Project	The Falls on Refugee Road	Addendum Number	3
Project Number	23446	Date	07/10/2025
To	All Bidders

This addendum contains changes to the requirements of the bidding Documents, Project Manual and Construction Drawings which have been issued to date. Such changes are to be incorporated into the Construction Documents and shall apply to the work in the same meaning and force as if they had been included in the original documents. Wherever this Addendum modifies a portion of a paragraph of the Project Manual or a portion of any Drawing, the remainder of the paragraph or Drawing shall remain in force.

DRAWING TITLE:	
SANITARY DETAILS	
	05/01/2025
	23446
	 C306
	CD PROGRESS SET

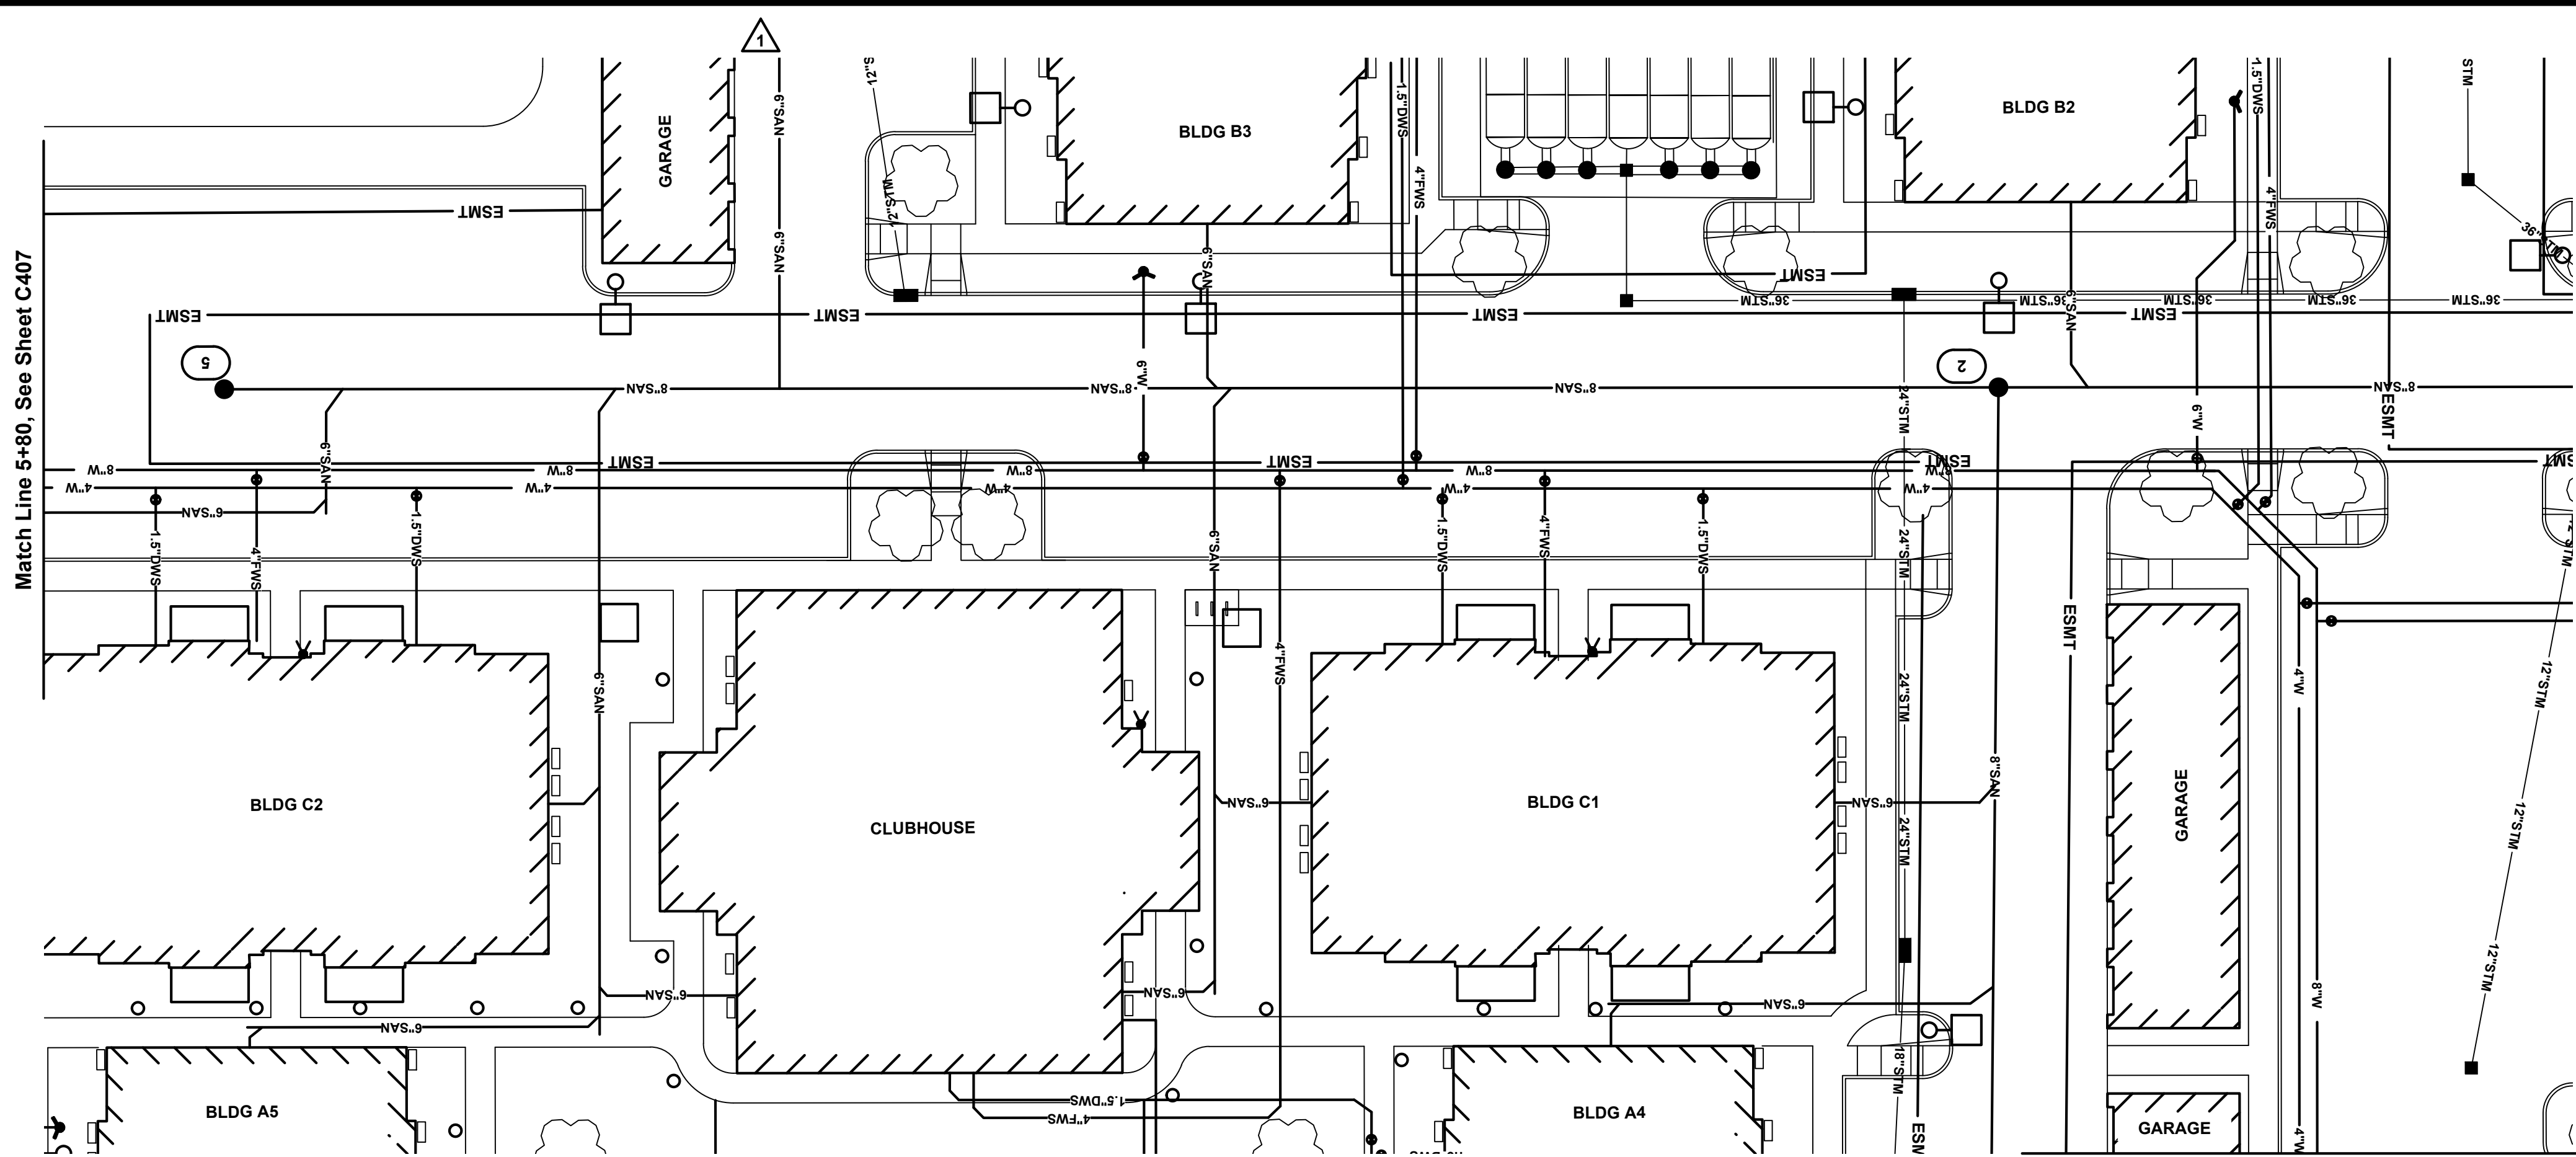
19. SHEET C306 – SANITARY DETAILS

- A. **REVISED** Sanitary Service Schedule Table for services S1, S2, S5, S6, S13, S14, S16, S17, S19.
